Authorized Field Change

AFC G-06901

Subject: Rocker Arm Replacement Kit for International® VT 365 Engines used in International® 3200, 4200 Models Built Between November 1, 2001 and December 31, 2002

Figure 3 Injector Clamp Designs - Early "C"- Type (left), Current (right)

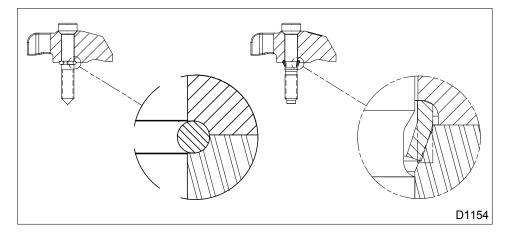
- 3/8" rocker arm pivot balls
- Rocker arm pivots and pivot retainers
- Injector hold down clamp bolt retainers -"C" type only, see Figure 3 below.

Figure 9 Rocker Arm Retaining Clip Designs

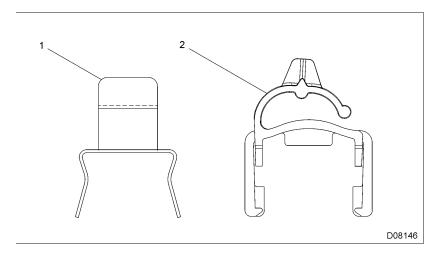
- 1. Plate Properly Positioned on Top of Valve Bridges
- 2. Exhaust Rocker Arm
- 7. Disengage rocker arm from push rod while rotating rocker arm and compressing rocker arm clip simultaneously. Remove rocker arm and retaining clip (see Figure 9) (early design). Repeat procedure for adjacent rocker arm.

Install new plastic rocker arm retaining clip (See Figure 11) (current design) by positioning top of clip to top of rocker arm opening and rotating clip snapping into position around fulcrum plate. Refer to illustration below for correctly installed clip (See Figure 12). Repeat procedure with adjacent rocker arm.
